# RECALL 21V701 REMEDY INSTRUCTIONS

Make(s): SPORTSCOACH  
Model(s): MANY, SEE BELOW  
Model Year(s): 2021 THROUGH 2022

Concern:  
The cooktop could be stowed with the burner still lit and cause a fire risk or injury.

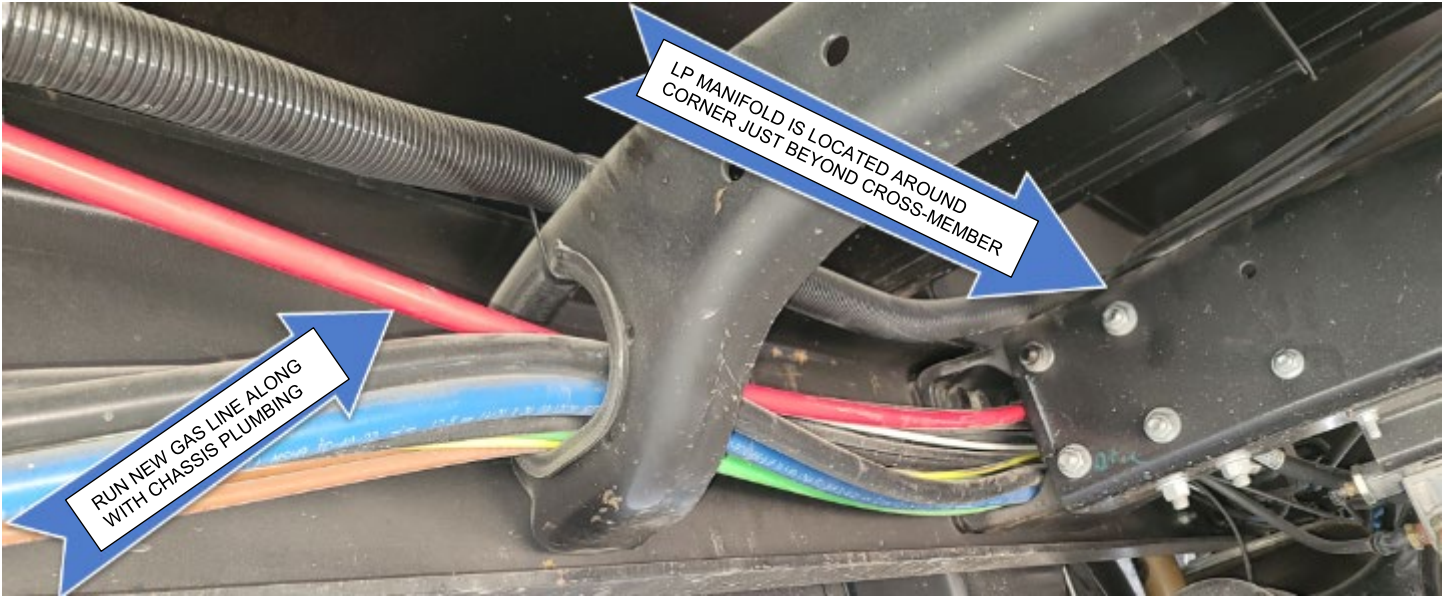
STEP 1: REMOVE EXISTING QUICK DISCONNECT BRACKET FROM CHASSIS TRUSS;

STEP 2: REMOVE GAS LINE FROM THE LP MANIFOLD;

STEP 3: INSTALL GAS LINE THAT WAS PROVIDED WITH SERVICE KIT INTO THE NOW OPEN PORT IN MANIFOLD. BE CERTAIN THREAD SEALER IS USED. THREAD SEALER **MUST** BE LP GAS COMPATIBLE.

STEP 4: ONCE NEW LINE IS INSTALLED IN MANIFOLD PASS THE OTHER END AROUND TRUSS AND SEND TOWARD FRONT OF UNIT. SECURE GAS LINE TO TRUSS NEAR MANIFOLD WITH SUPPLIED P-CLAMP AFTER EXCESS HOSE IS PULLED THROUGH.

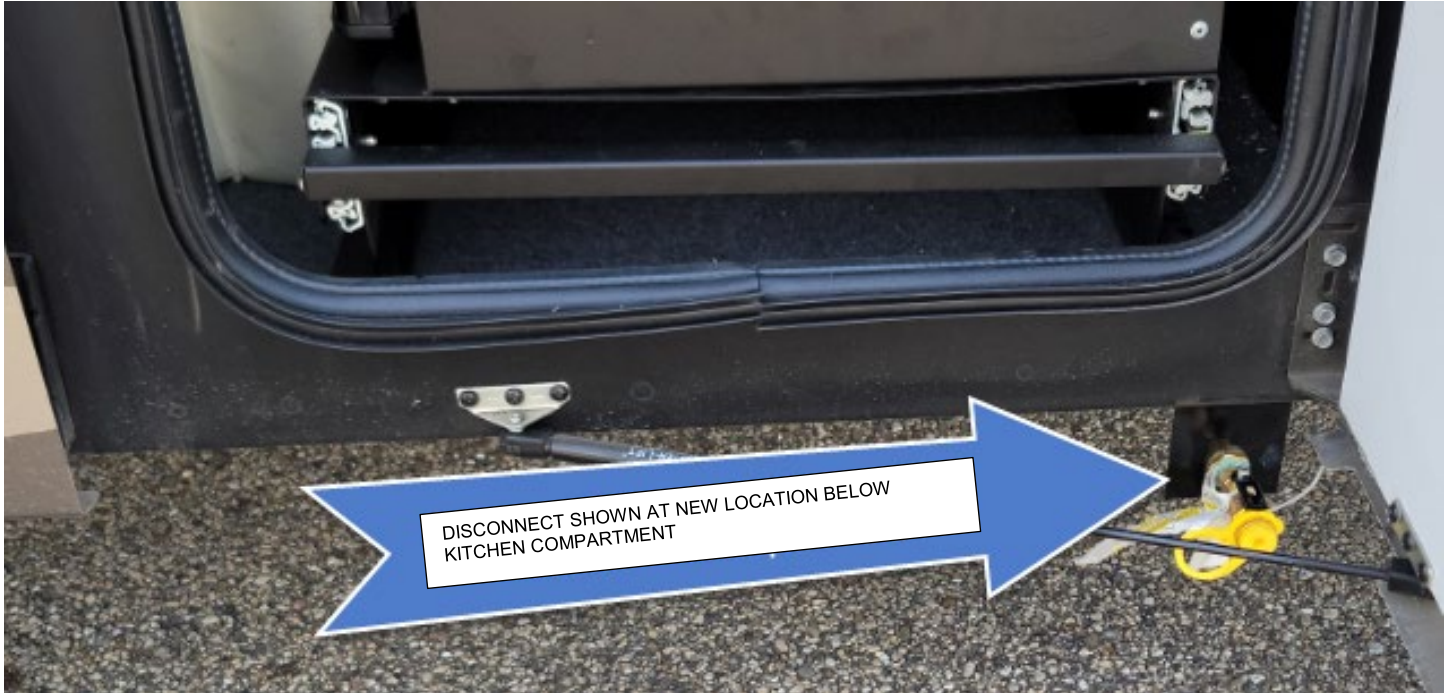
STEP 7: SECURE GAS LINE AT THE TOP OF TRUNK STRUCTURE WHERE LINE PASSES OVER THE FRAME. USE SUPPLIED P-CLAMP.

STEP 8: SECURE GAS LINE TO THE SIDE OF LOWER STRUCTURE. BE SURE TO LIMIT SLACK BETWEEN SECUREMENTS. EXTRA HARDWARE IS SUPPLIED, USE AS SEE FIT.

STEP 9: NEW BRACKET AND DISCONNECT SHOULD BE INSTALLED AS FAR FORWARD AS ON COMPARTMENT AS POSSIBLE. SECURE GAS LINE TO DISCONNECT.

NEW DISCONNECT LOCATION SHOWN ABOVE AT FRONT SIDE RIGHT BELOW COMPARTMENT. USE NEW QUICK DISCONNECT HOSE THAT WAS PROVIDED WITH PARTS KIT TO CONNECT TO RANGE.
